Product Change Notification

1. ECR #: 208864
Notification #: 613

3. Series:
• MEC6 - .635mm RIGHT ANGLE EDGE CARD ASSEMBLY

4. Part #'s Affected
• MEC6-150-02-%-DV-A-K
• MEC6-150-02-%-DV-A

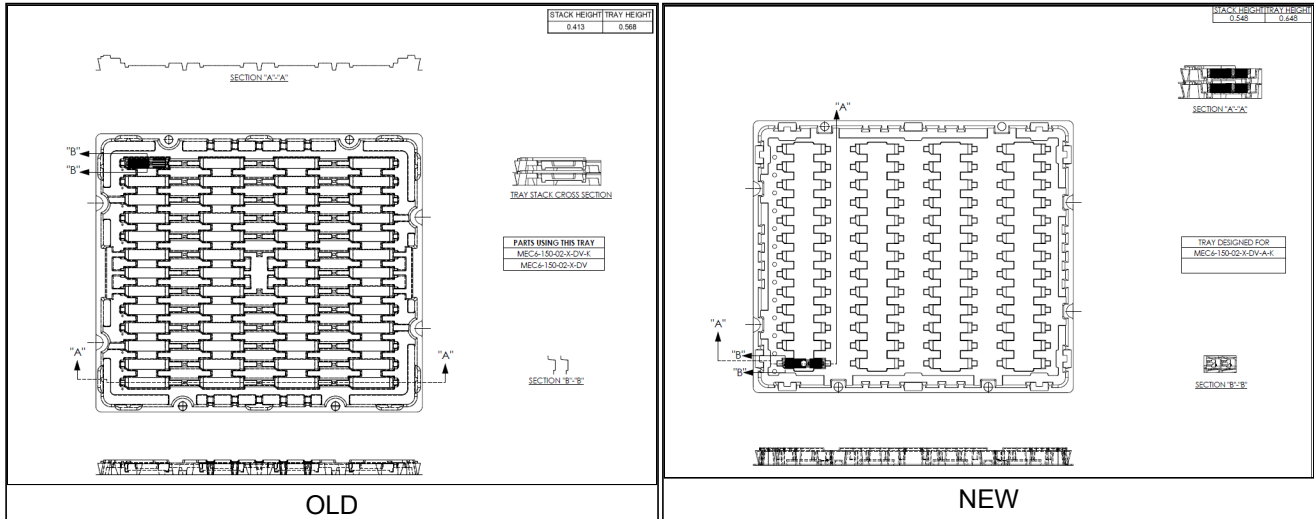
5. Description of Change:
Tray height has been modified

7. Reason for Change:
Changes are being made to improve the manufacturability

8. Impact of Change on Form, Fit, or Function:
• Fit - Tray height & stack height

6. Method of Identifying Change
Change tray height .568" to .648" & stack height .413" to .548"
